Access Compliance Report

Public Rights-of-Way

(Curb Ramps)

Intersection ID: 51061	Main Street: CORY-BRET_LN	Cross Street: TIPPERLINN_WY	Location: NW
ADA ID: 8574C8CF2696	Ramp Type: PerpDiag	Initial Pass/Fail: Fail	Overall Compliance: No
			Severity Score: 33.75

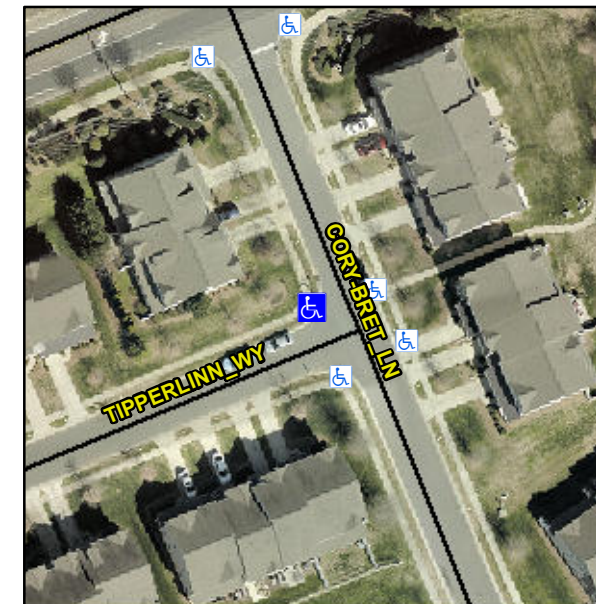
Not Found, R304.5.1, R304.5.3

Compliance	Description	Data	Compliance	Description	Data
N/A	Ramp Length (in)	47.0	Yes	Ramp Slope (%)	6.3
No	Ramp Width (in)	47.0	No	Ramp XSlope (%)	7.1
N/A	Flare Type LT	N/A	N/A	Flare Type RT	N/A
N/A	Flare Slope LT (%)	N/A	N/A	Flare Slope RT (%)	N/A
N/A	Flare Traversable LT?	N/A	N/A	Flare Traversable RT?	N/A
N/A	Landing Length (in)	N/A	N/A	DWS Provided?	N/A
N/A	Landing Width (in)	N/A	N/A	DWS Contrast?	N/A
N/A	Landing Slope (%)	N/A	N/A	DWS Length (in)	N/A
N/A	Landing X Slope (%)	N/A	N/A	DWS Full Width?	N/A
N/A	Landing Curb? (Y/N)	N/A	N/A	DWS Offset (in)	N/A
N/A	Shared Landing?	N/A			
N/A	Gutter Ponding?	N/A	N/A	Gutter Slope (%)	N/A
N/A	Gutter Lip Ht (in)	N/A	N/A	Gutter X Slope (%)	N/A
N/A	Painted X Walk1?	No	N/A	Painted X Walk2?	No
	X Walk 1 Direction	To SE		X Walk 2 Direction	To E
N/A	X Walk 1 Width (in)	N/A	N/A	X Walk 2 Width (in)	N/A
	X Walk 1 Slope (%)	5.1		X Walk 2 Slope (%)	3.4
	X Walk 1 X Slope (%)	4.1		X Walk 2 X Slope (%)	6.4

Remove & Replace Curb Ramp With Two New Directional Ramps or Equivalent.
